#### DEPARTMENT OF PLANNING AND DEVELOPMENT

DATE: March 9, 2018
TO: Councilor Auchincloss, Chair, Austin Street Liaison Committee
FROM: Barney Heath, Director of Planning and Development Jennifer Caira, Chief Planner – Current Planning Valerie Birmingham, Planning Associate
SUBJECT: 28 Austin Street Parking Lot and Rear Commercial Retail Corridor

## 28 AUSTIN STREET - GROUND LEVEL

# ATTACHMENT A

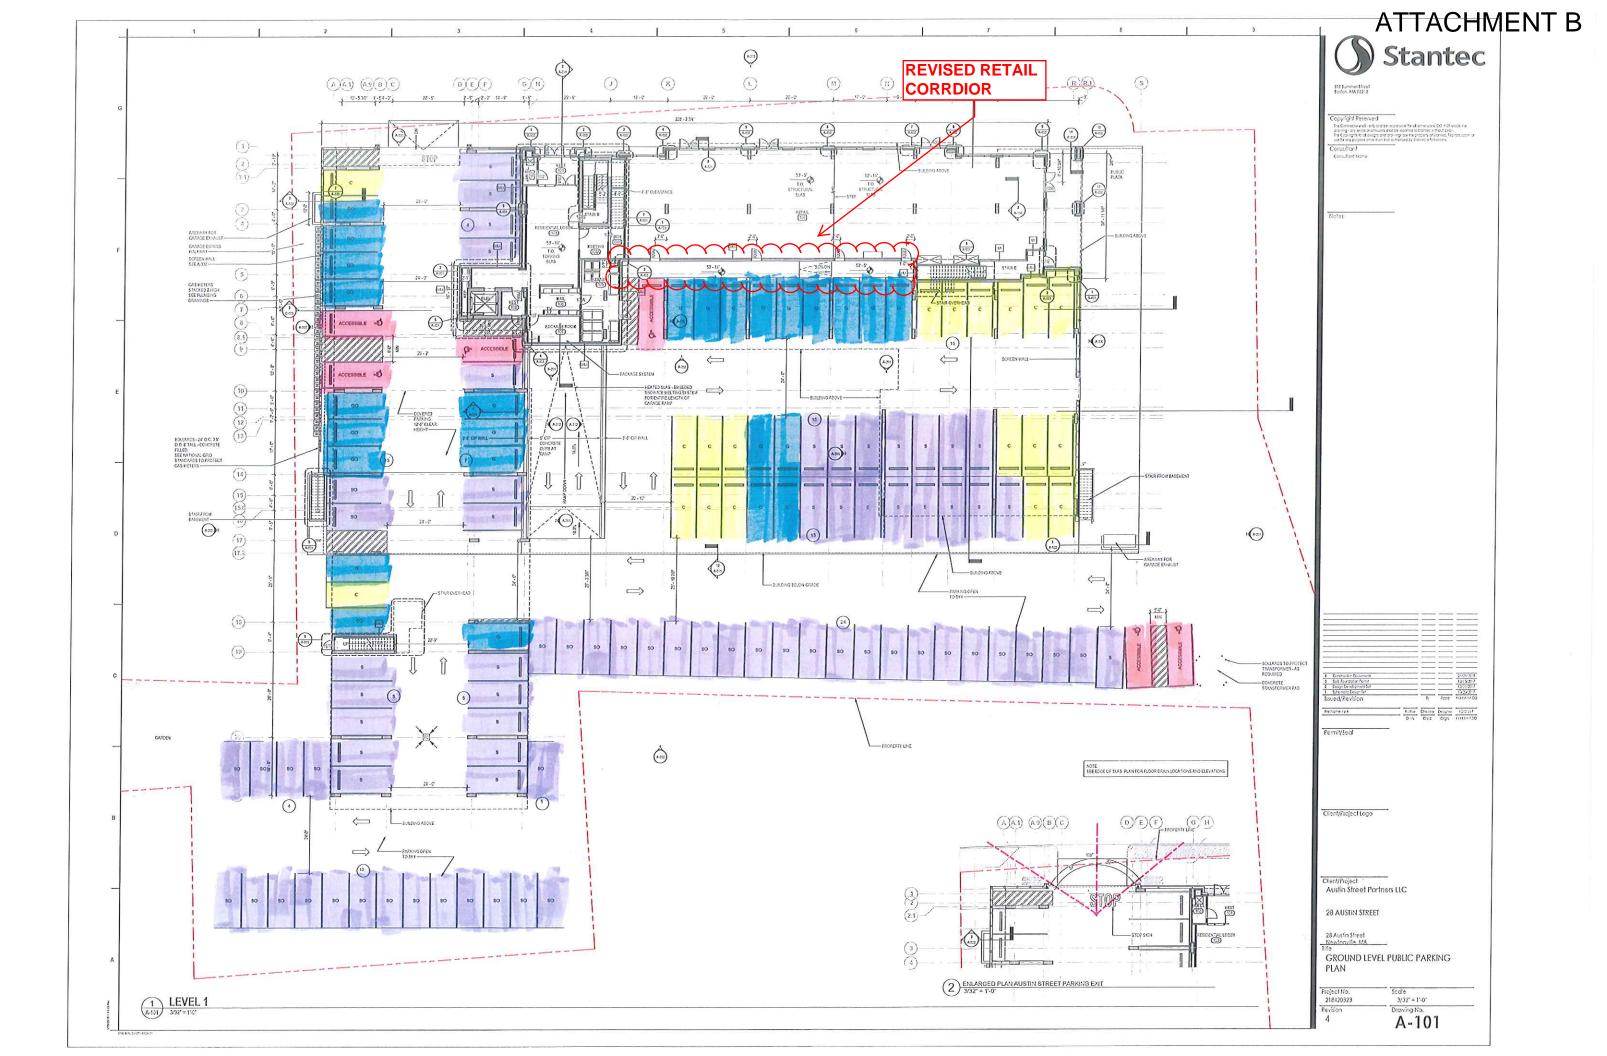
The new ground level public parking design locates 8'0"-wide stalls in the aisles south of the commercial portion of the building, which were previously designated as both 8'4" and 8'6"-wide stalls in the 2015 approved plans. (Attachments A and B) The total number of stalls has increased by one, and number of compact stalls has remained the same (Attachment C), however the location of some of the compact stalls has changed. Where the approved 2015 plans located three 8'0" wide stalls in the northeast corner of the ground level parking garage, there are now six 8'0" stalls in this location. Furthermore, where the 2015 approved plans located three 8'6" wide stalls just south of the previously described stalls, the new design now shows them as 8'0" wide stalls. In addition to the reconfiguration of standard and compact parking stall locations, the location of support posts within the lot has also changed and the number of posts has decreased. After consulting with the City's Department of Public Works (DPW), Traffic Division, staff has determined that the new design is appropriate for the site's approved parking configuration and is an improvement from the previously approved design as the smaller stall size (8'0") will be signed for only compact vehicles. As the approved 2015 design did not include a bump out for cars to turn around at the eastern end of the parking aisle, the location of smaller spaces at this end is actually preferable. Given the tight space in comparison to the rest of the site, it would be most beneficial if limited to smaller, compact vehicles. The reduced number of posts also improves the overall parking design in comparison to the approved 2015 design. In addition, Special Permit #119-15

Staff finds the changes to the location of compact stalls, in addition the reduced number of posts represent a relatively minor change from the approved 2015 plans and an overall improvement to the operation and safety of the parking lot. Furthermore, staff has determined that the tight space at end of aisles and the visibility for stalls located next to walls or columns are manageable and did exist as a part of the 2015 plan approved by City Council, then the Board of Alderman.
